UNITED STATES PATENT AND TRADEMARK OFFICE

Office Action Summary

10/708,879

DETAILED ACTION

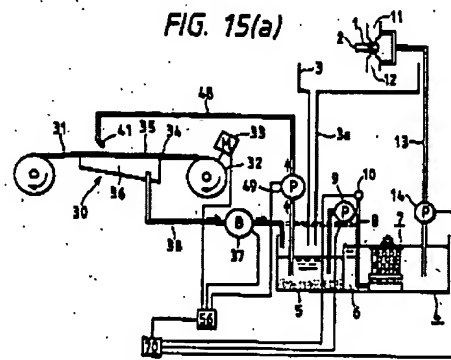
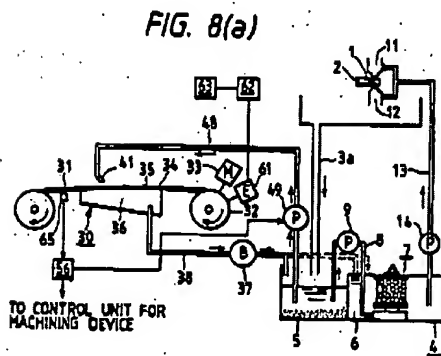
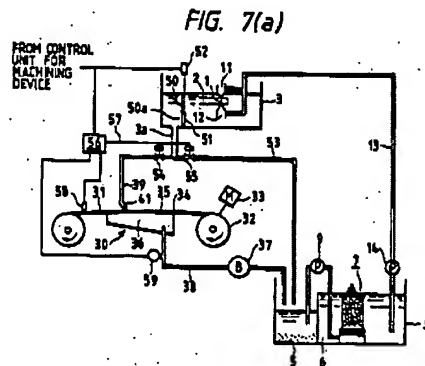
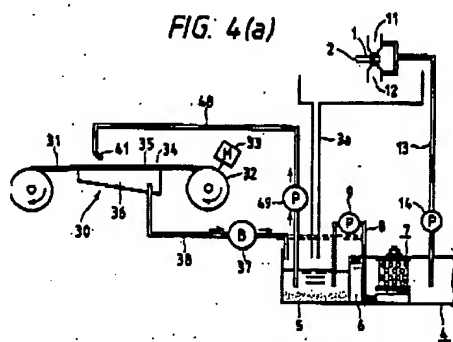
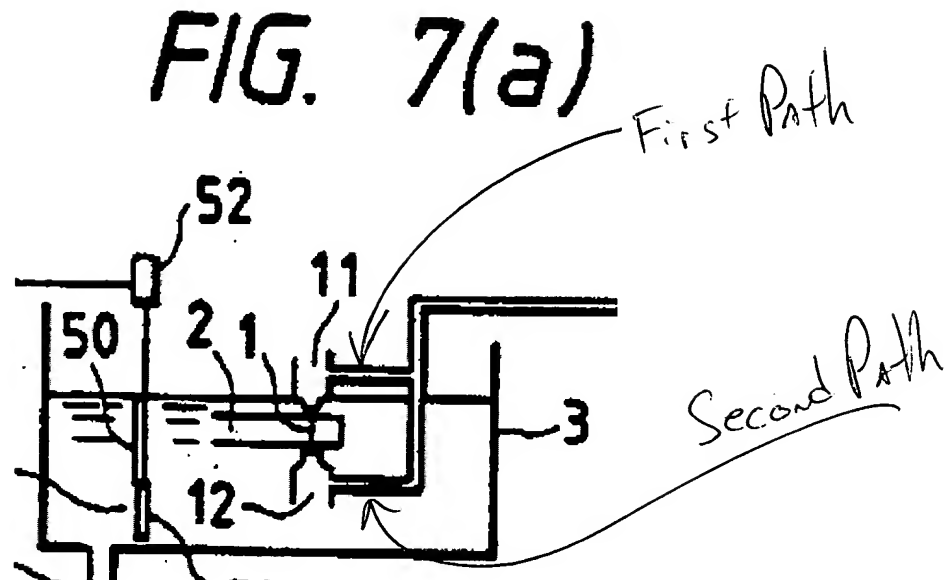
Claims 1-3,5,7,8,10 and 13-15,19,20 and 22 are rejected under 35 U.S.C. 102(b) as being anticipated by. See Figures 4(a), 7(a), 8(a) and 15(a) each of which illustrates two stage filtration in an EDM:
